Access Compliance Report

Public Rights-of-Way

Intersection ID: 17342	Main Street: AUTUMN_RAIN_LN	Cross Street: KIRKFIELD_CT	Location: NW
ADA ID: CEE5C2F417B3	Ramp Type: PerpDiag	Initial Pass/Fail: Fail	Overall Compliance: No
Severity Score: 37.5			
Codes/Mitigation Info/Possible Solution		Field Measurements/Component Compliance

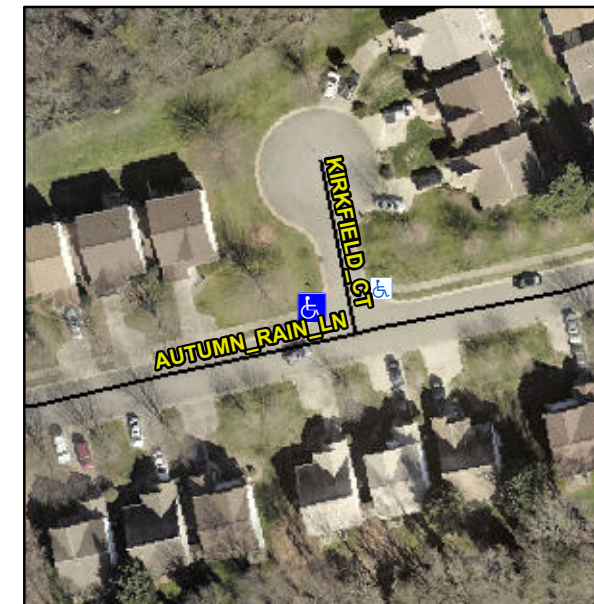
Not Found, R304.2.2, R304.5.3

Compliance	Description	Data	Compliance	Description	Data
N/A	Ramp Length (in)	51.0	No	Ramp Slope (%)	10.6
Yes	Ramp Width (in)	72.0	No	Ramp XSlope (%)	7.5
N/A	Flare Type LT	N/A	N/A	Flare Type RT	N/A
N/A	Flare Slope LT (%)	N/A	N/A	Flare Slope RT (%)	N/A
N/A	Flare Traversable LT?	N/A	N/A	Flare Traversable RT?	N/A
N/A	Landing Length (in)	N/A	N/A	DWS Provided?	N/A
N/A	Landing Width (in)	N/A	N/A	DWS Contrast?	N/A
N/A	Landing Slope (%)	N/A	N/A	DWS Length (in)	N/A
N/A	Landing X Slope (%)	N/A	N/A	DWS Full Width?	N/A
N/A	Landing Curb? (Y/N)	N/A	N/A	DWS Offset (in)	N/A
N/A	Shared Landing?	N/A			
N/A	Gutter Ponding?	N/A	N/A	Gutter Slope (%)	N/A
N/A	Gutter Lip Ht (in)	N/A	N/A	Gutter X Slope (%)	N/A
N/A	Painted X Walk1?	No	N/A	Painted X Walk2?	No
	X Walk 1 Direction	To S		X Walk 2 Direction	To E
N/A	X Walk 1 Width (in)	N/A	N/A	X Walk 2 Width (in)	N/A
	X Walk 1 Slope (%)	3.4		X Walk 2 Slope (%)	4.5
	X Walk 1 X Slope (%)	4.8		X Walk 2 X Slope (%)	1.8

Remove & Replace Curb Ramp With Two New Directional Ramps or Equivalent.
